Re: **COMBINED STORMWATER MANAGEMENT
CONCEPT/SITE DEVELOPMENT
STORMWATER MANAGEMENT PLAN** for
7000 Wisconsin Avenue
Preliminary Plan #: 120200090
Site Plan #: 820200090
SM File #: 285598
Tract Size/Zone: 0.46 Ac. / CR-3.0,C-3.0,R-2.75
Total Concept Area: 0.49 Ac
Lots/Block: 5, 6, 6-A
Parcel(s): P1
Watershed: Little Falls Branch

**Department of Permitting Services
Fire Department Access and Water Supply Comments**

RE: Preliminary Plan No. 12020090
7000 Wisconsin Avenue

Re: 7000 Wisconsin Avenue
Site Plan No. 820200090

TITLE
FIRE DEPARTMENT ACCESS PLAN

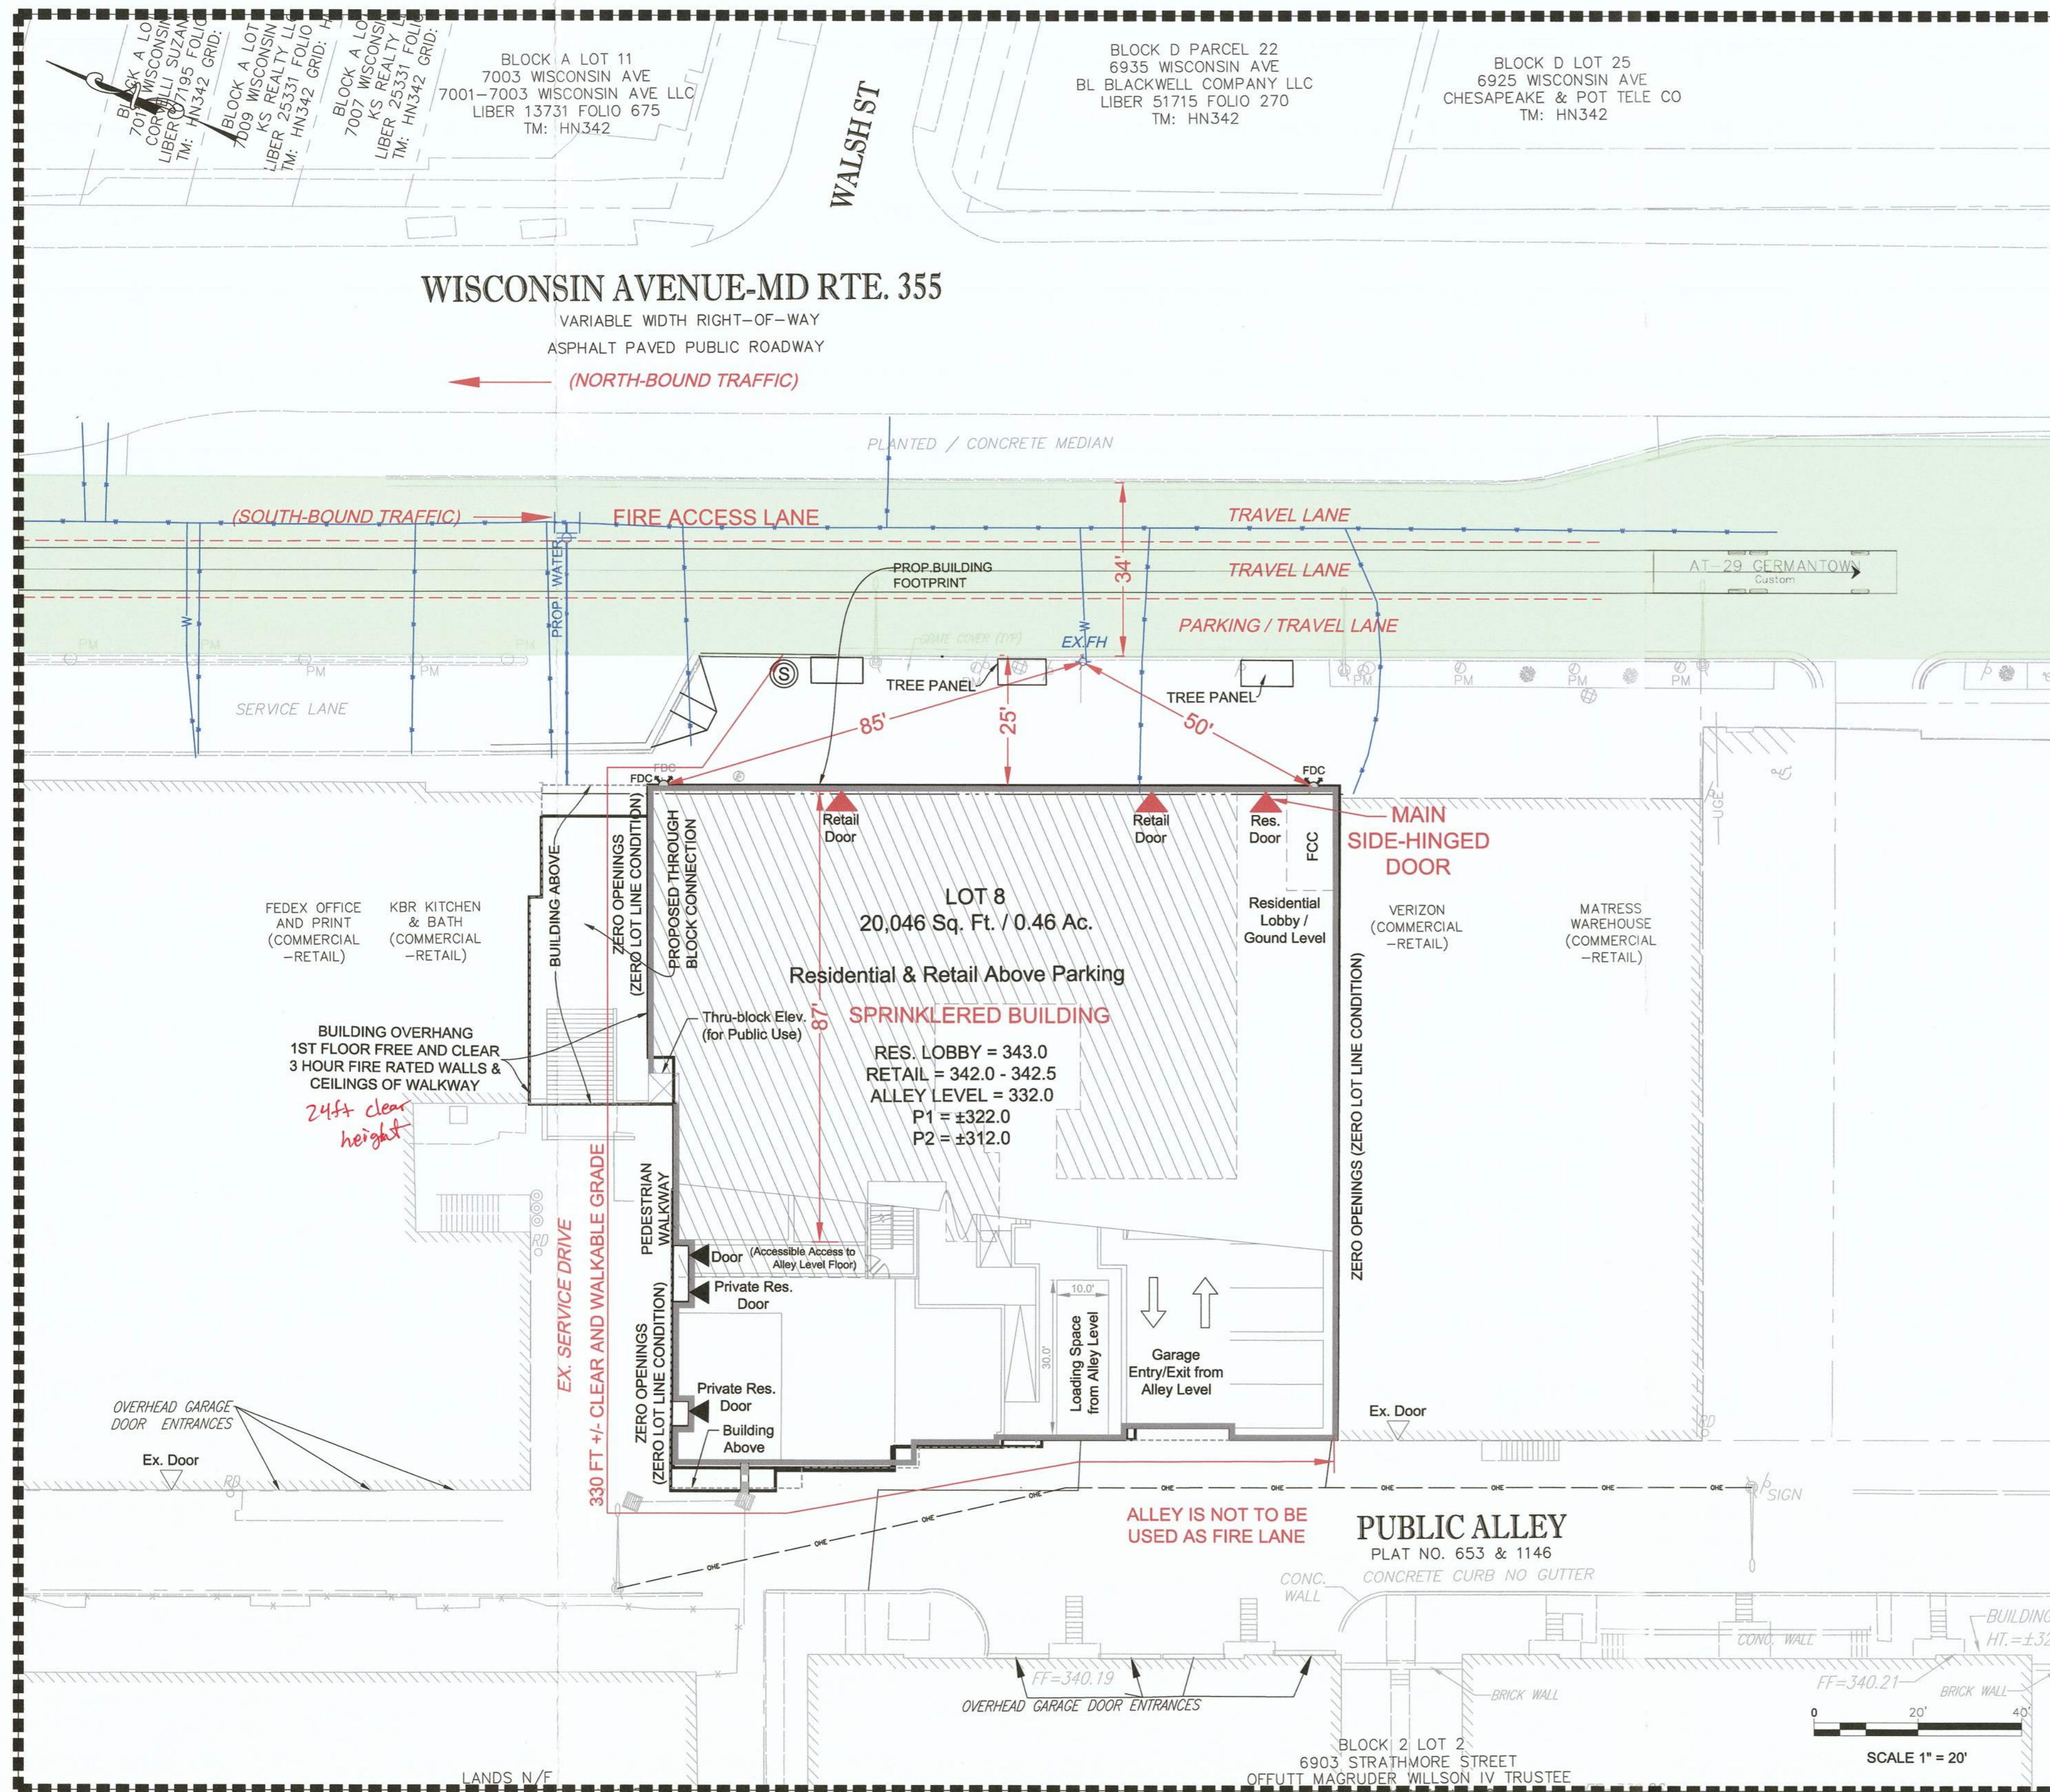
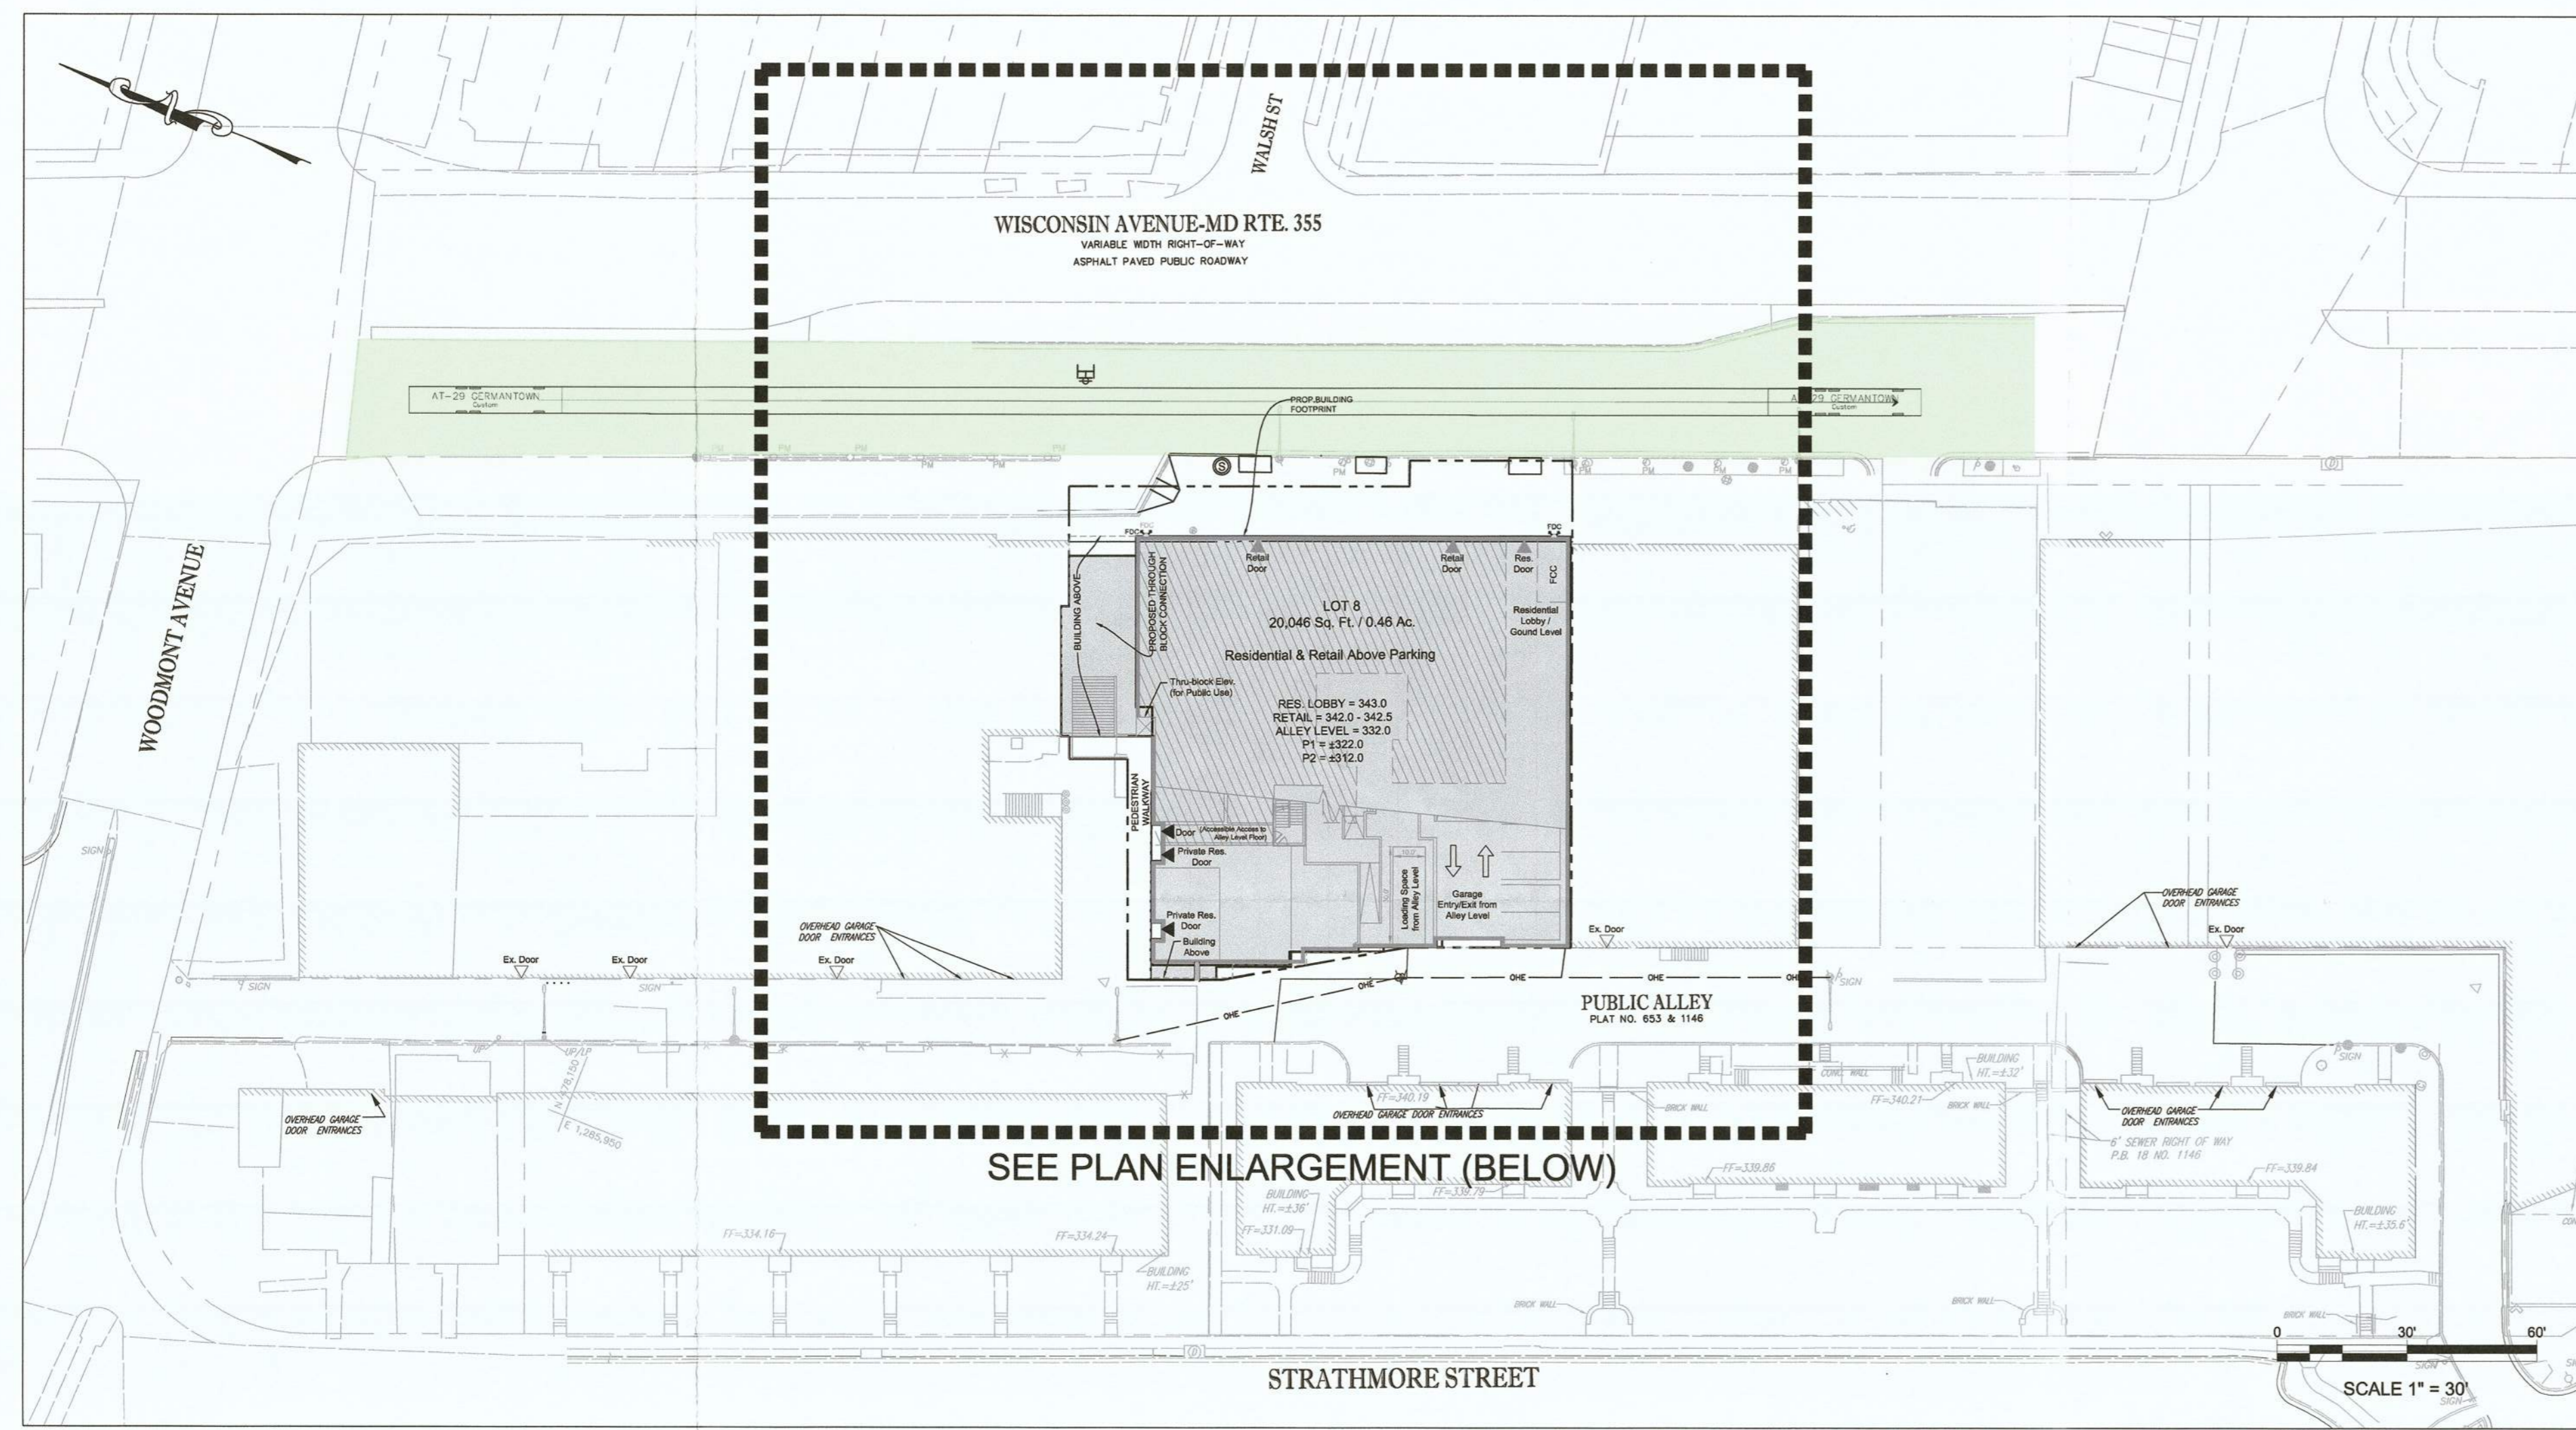
PLAN APPROVED

***** See statement of performance based design: fire rated walls and ceiling at building overhang

BY: *SJC* FM: 43 DATE: 3/12/20
